Project	<b>IEEE 802.16 Broadband Wireless Access Working Group</b> < <a href="http://ieee802.org/16">http://ieee802.org/16</a> >	
Title	<b>Comments on User Bitmap Position Change for IEEE P802.16m/D1 (15.2.8.3.3)</b>	
Date Submitted	<b>2009-08-28</b>	
Source(s)	Yih-Guang Jan, Yang-Han Lee, Hsien-Wei Tseng, Ming-Hsueh Chuang, Jheng-Yao Lin <b>Tamkang University (TKU)</b>	Yih-Guang Jan, Yang-Han Lee, Hsien-Wei Tseng, Ming-Hsueh Chuang, Jheng-Yao Lin <b>Tamkang University (TKU)</b>
	Youn-Tai Lee, Chun-Yen Hsu <b>Institute for Information Industry (III)</b>	Youn-Tai Lee, Chun-Yen Hsu <b>Institute for Information Industry (III)</b>
	Shiann-Tsong Sheu <b>National Central University (NCU)</b>	Shiann-Tsong Sheu <b>National Central University (NCU)</b>
	Whai-En Chen <b>National Ilan University (NIU)</b>	Whai-En Chen <b>National Ilan University (NIU)</b>
	Shiunn-Jang Chern <b>National Sun Yat-sen University(NSYSU)</b>	Shiunn-Jang Chern <b>National Sun Yat-sen University(NSYSU)</b>

## **Comments on User Bitmap Position Change for IEEE P802.16m/D1 (15.2.8.3.3)**

Figure 420-Example of re-arrange user bitmap

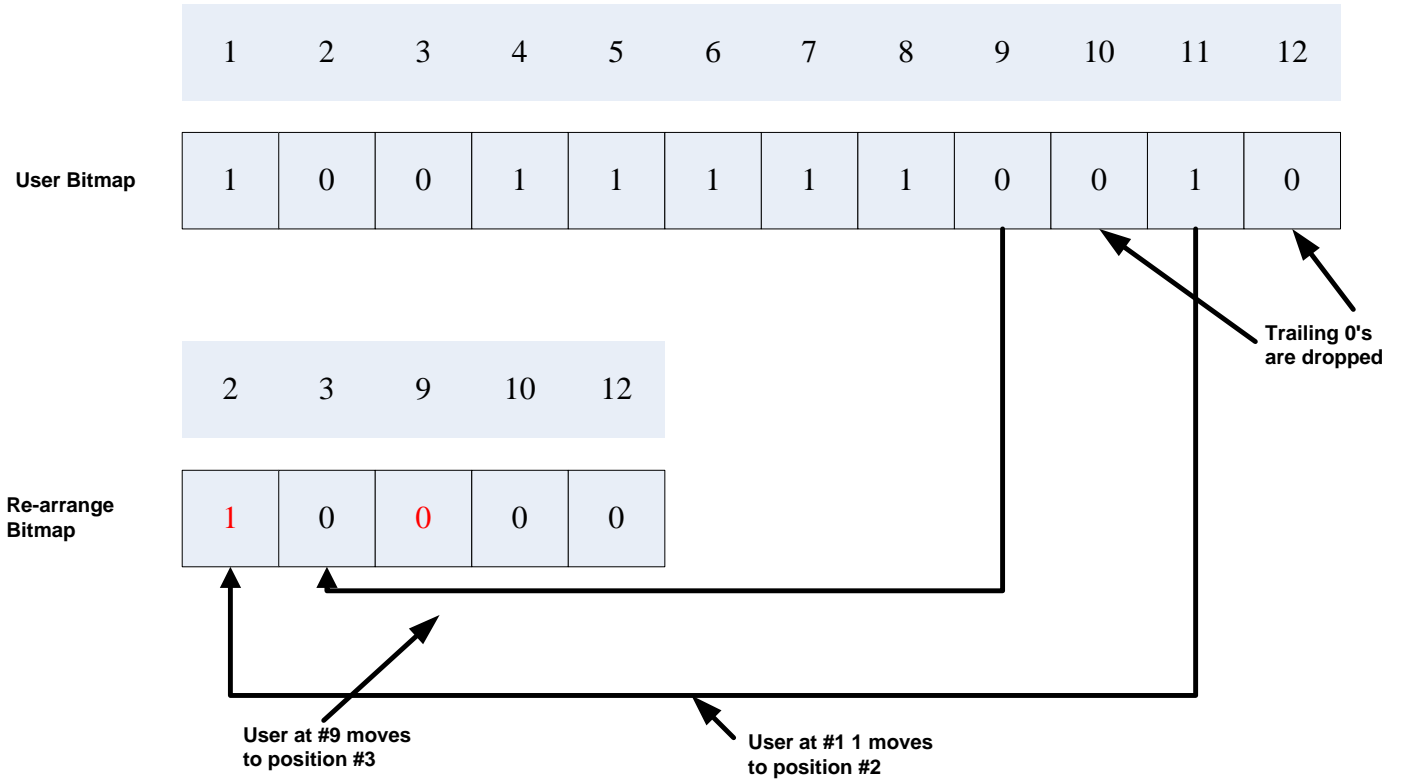
This contribution provides the corrected figure in the description of User Bitmap Position Change. It has errors in Figure 420 in the description of ‘Re-arrange of User Bitmap’.

*[In IEEE P80216m/D1, Section 15.2.8.3.3, replace Figure 420 by the following corrected figure]*
